MONTGOMERY COUNTY HISTORIC PRESERVATION COMMISSION
STAFF REPORT

Address:	30 Hesketh Street, Chevy Chase	Meeting Date:	6/8/2022
Resource:	Contributing Resource Chevy Chase Village Historic District	Report Date:	6/1/2022
Applicant:	Kristen Donoghue and Jonathan Hacker (Neal Thomson, Architect)	Public Notice:	5/25/2022
Review:	HAWP	Tax Credit:	N/A
Permit Number:	936072 REVISION	Staff:	Michael Kyne
PROPOSAL:	Revisions to previously approved HAWP

PROPOSAL

The applicants propose to revise the previously approved HAWP.

A102

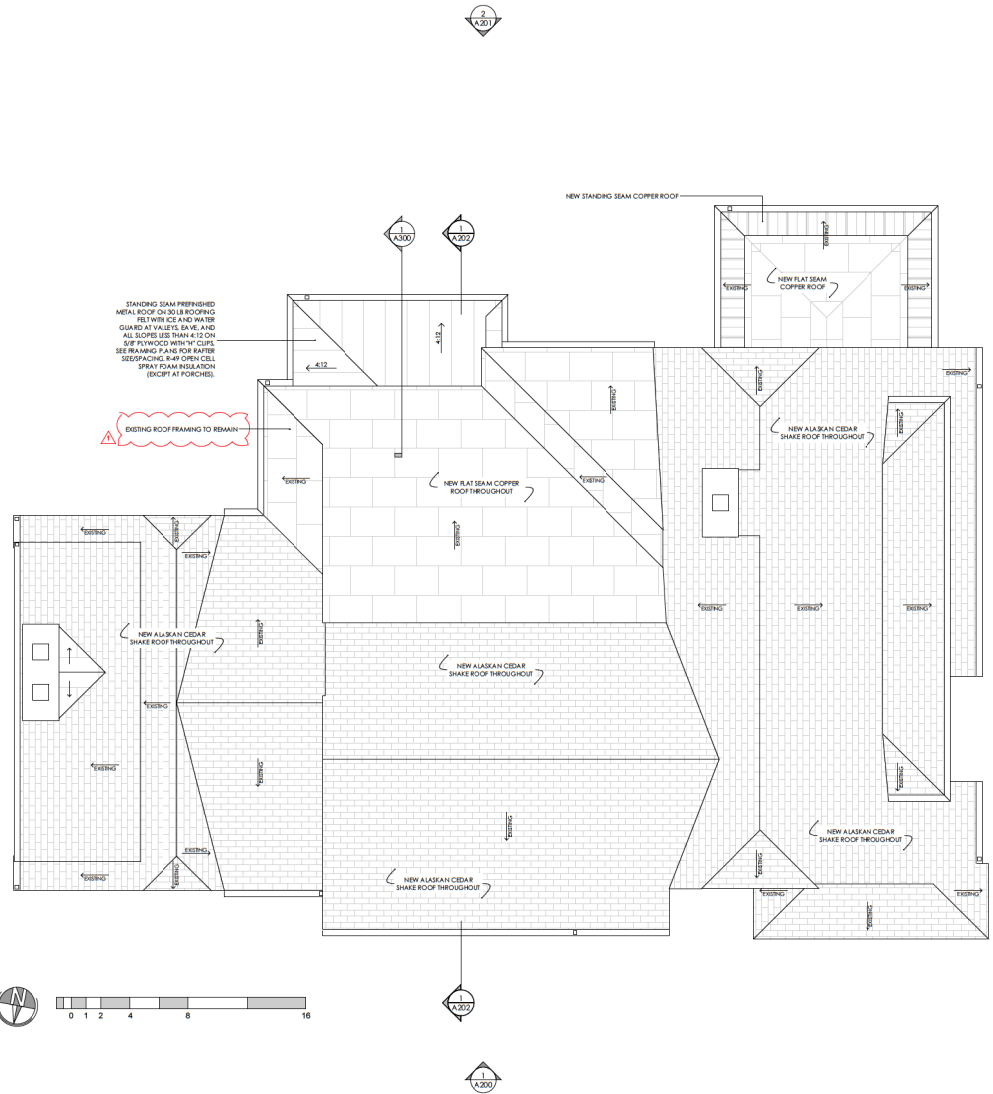
1. At the back of the house, we were originally proposing a larger breakfast bay and modifying the second floor in response to the first floor addition. However, due to budget revisions, we have decided to keep much of the existing second floor and first floor exterior walls in an effort to simplify structural requirements. This can be viewed in plan on sheets A101/A102 and on the rear elevation on sheet A201.

A200

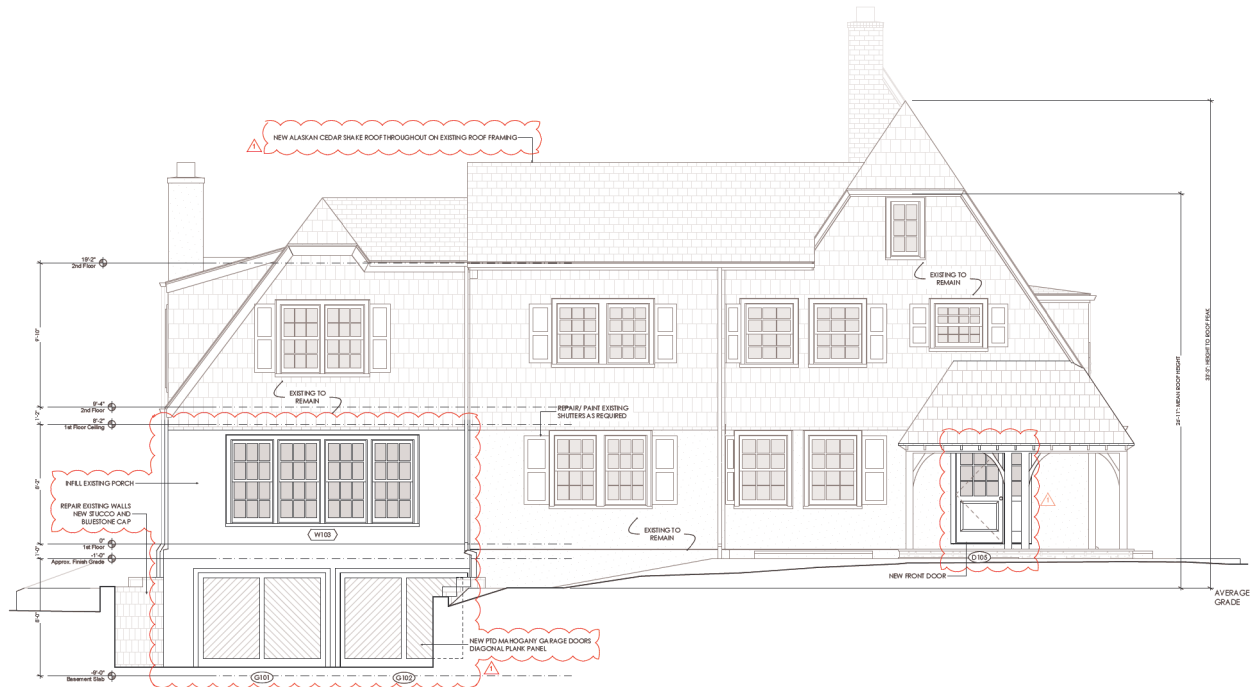
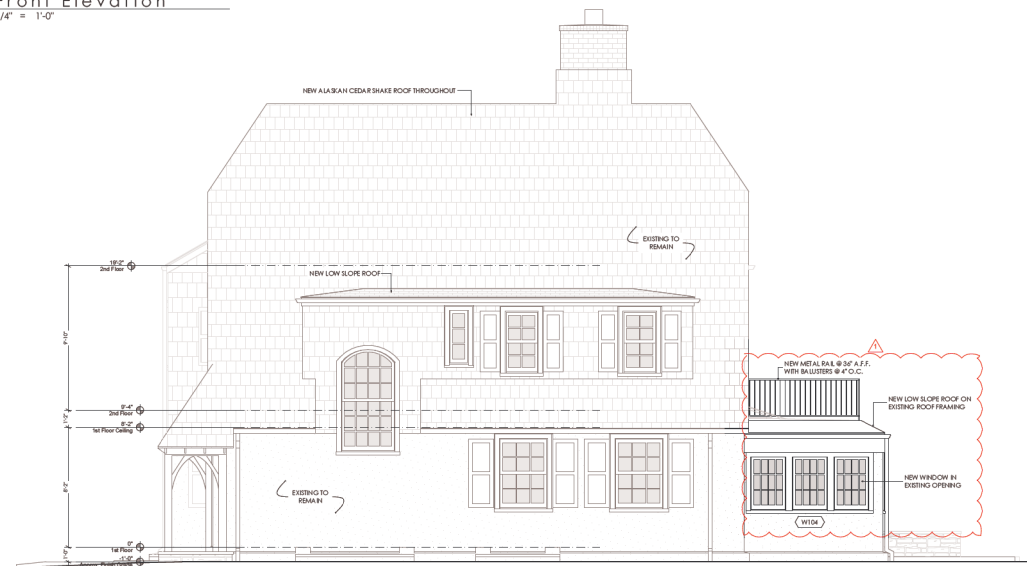
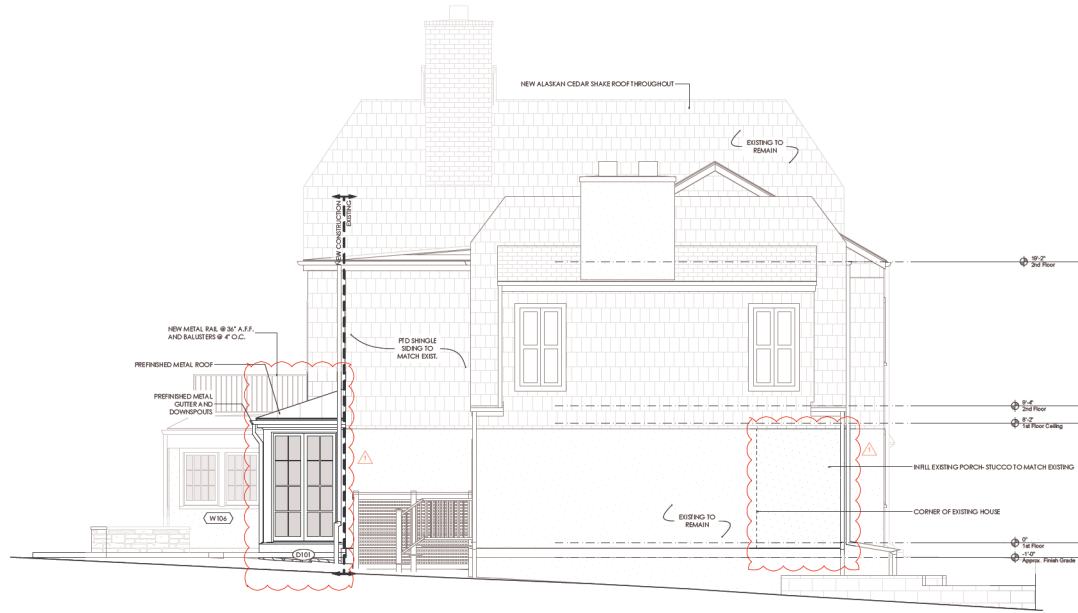
3. There is an existing covered porch at the front of the house on the Family Room side that was part of a 1970s addition. We are requesting that this porch be infilled to give more space to the family room and resolve any water infiltration issues above the garage below. The proposed walls will be finished in stucco and exterior details are to match the existing house. This can be viewed in plan on sheet A101 and in elevation on sheets A200/A201.
